| AGENDA ITEM  | SUBMITTED BY  | PRESENTED BY                           |
|--|---|--|
| <p><b>Resolution PC2026-01R:</b> A Resolution of the Town of Severance Planning Commission approving, with conditions, a Site Plan application for Platte Valley Veterinary Clinic on real property located within the Town of Severance, Lot 5 Block 1, Scotch Pine Commercial at Timber Ridge PUD</p>  | <p>Shani Porter, Planning Director</p>                      | <p>Shani Porter, Planning Director</p> |

4. RCE Response - TOS Comments 1st review memo

**SEVERANCE PLANNING COMMISSION  
RESOLUTION NO. PC2026-01R**

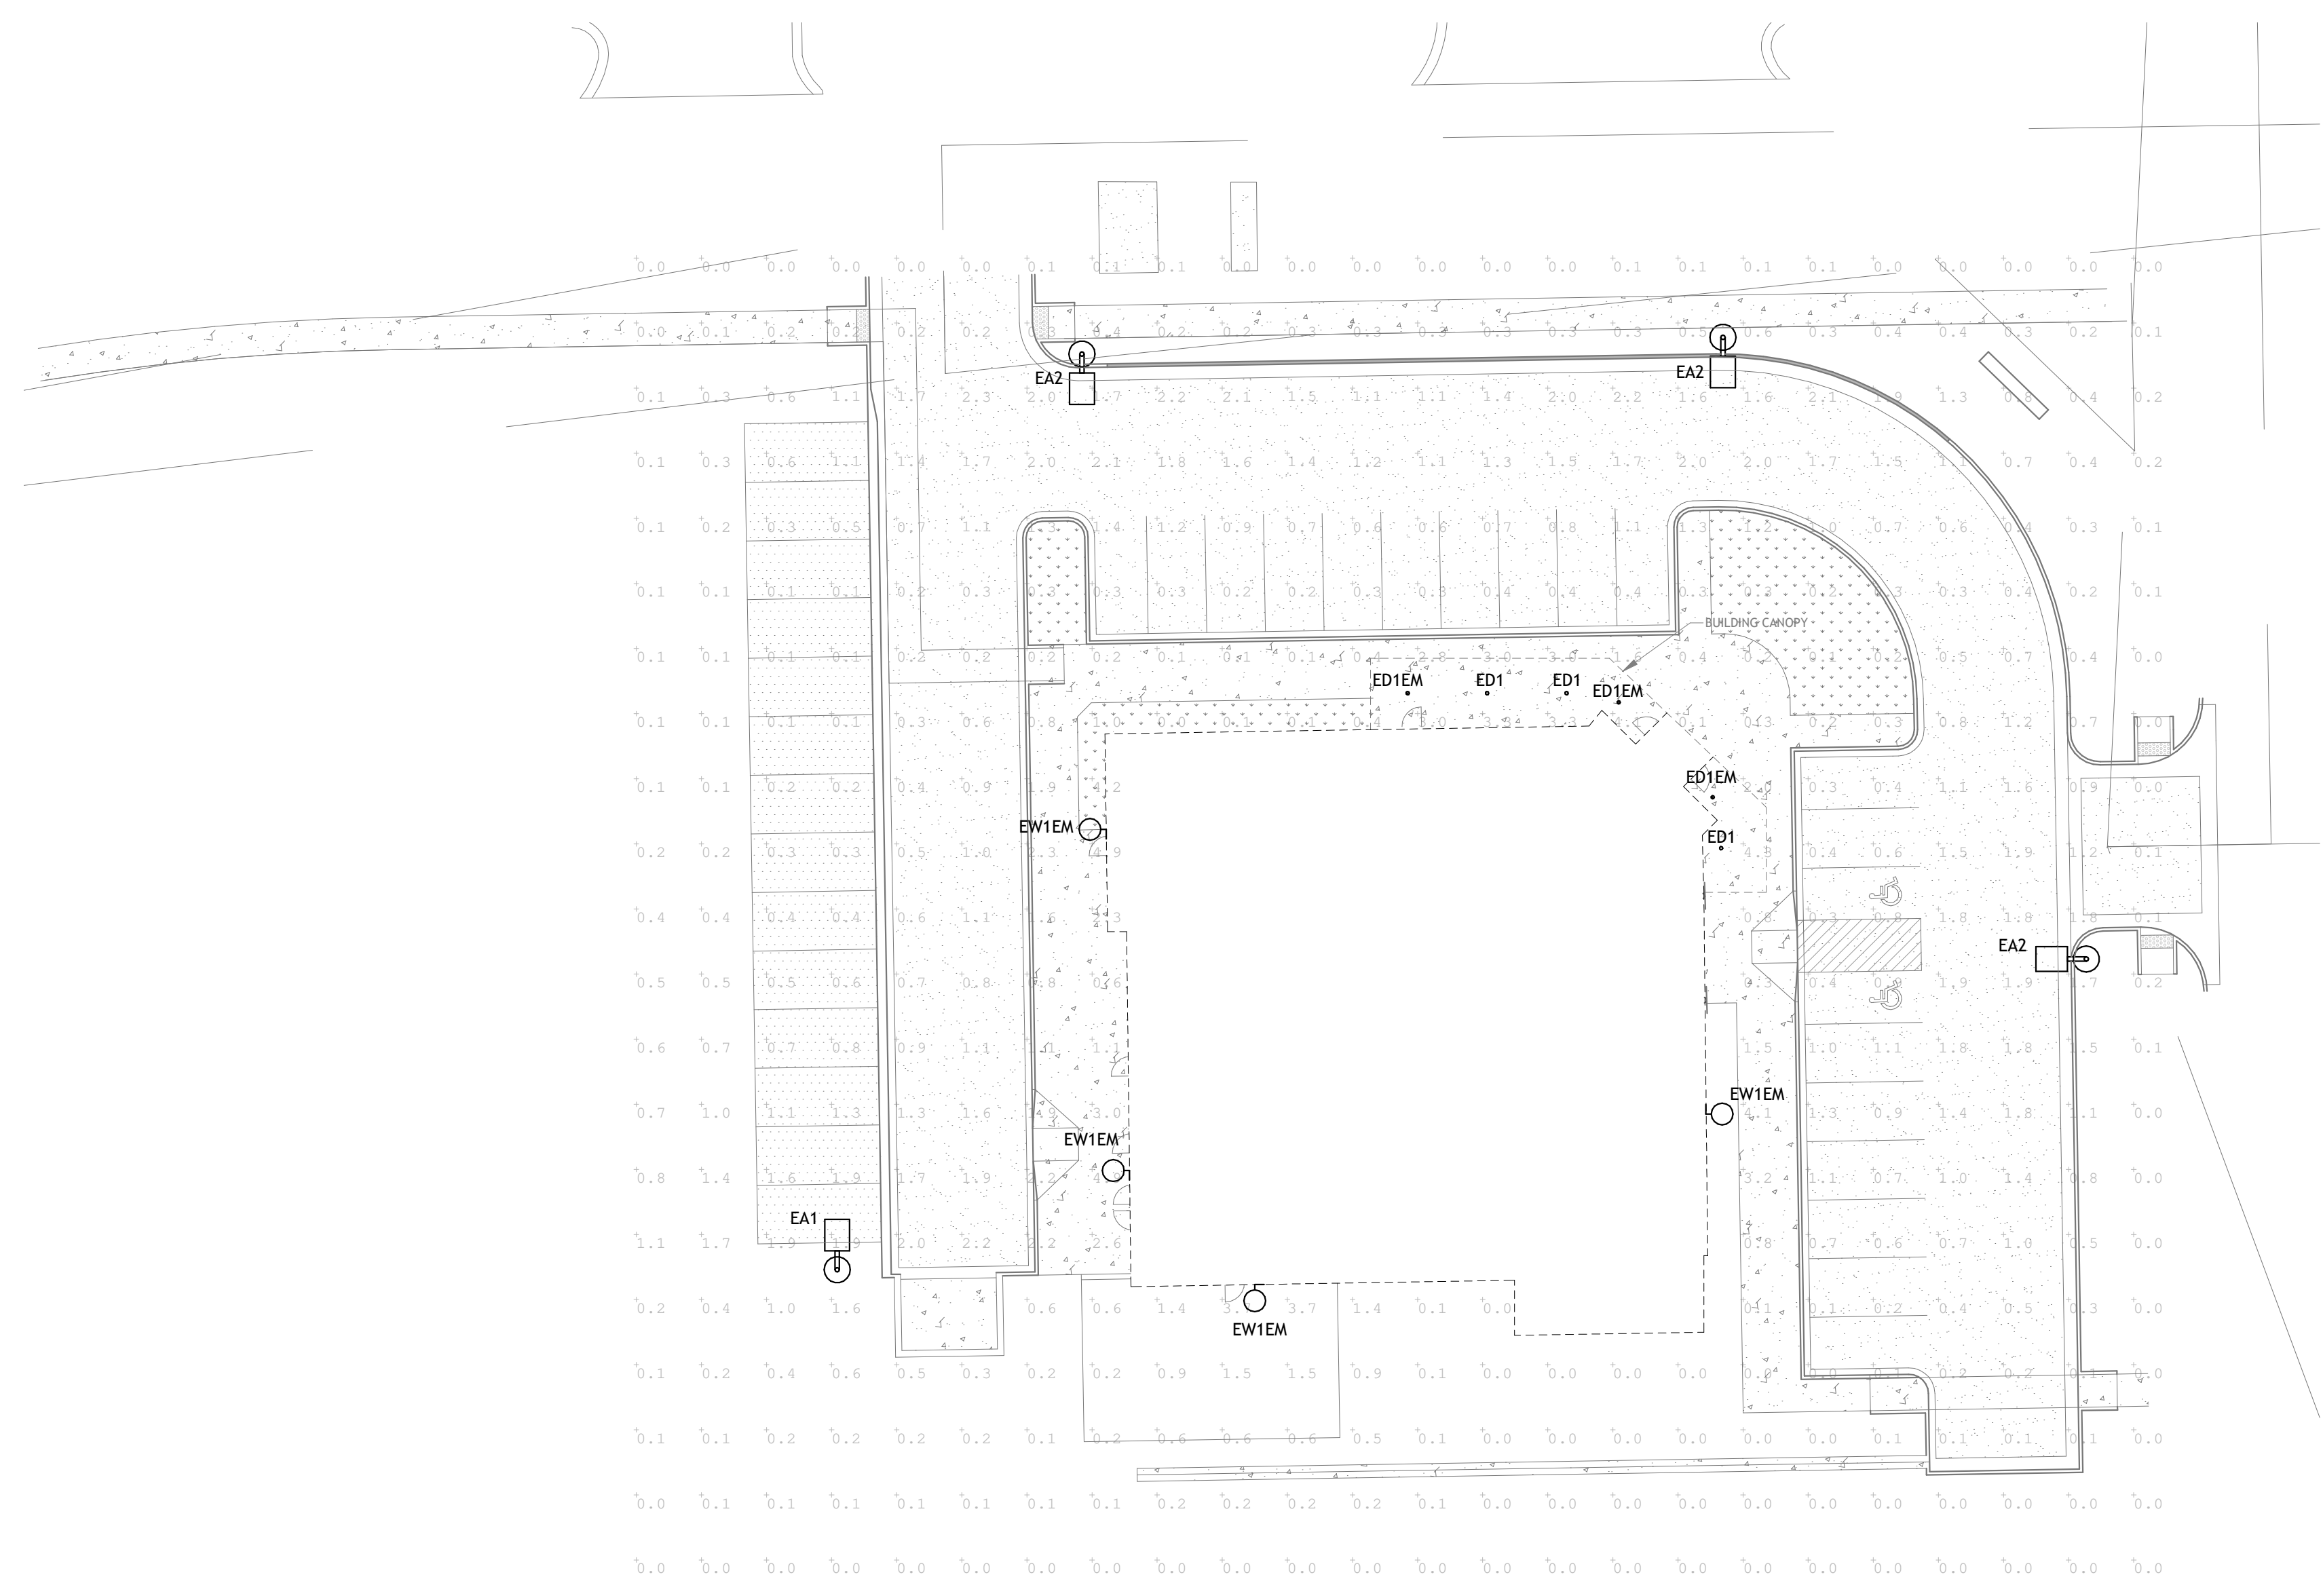
**27. Sheet 10: Lighting:** Maximum light levels along the property line to the west, north, and east is 0.2 footcandles and 0.1 footcandles to the south. There appear to be areas where the north and east edges of the site exceed this.

**28. Sheet 10: Lighting:** Maximum levels within the site are 5.0 footcandles in parking and building entries, 1.0 along pedestrian walkways away from the building.
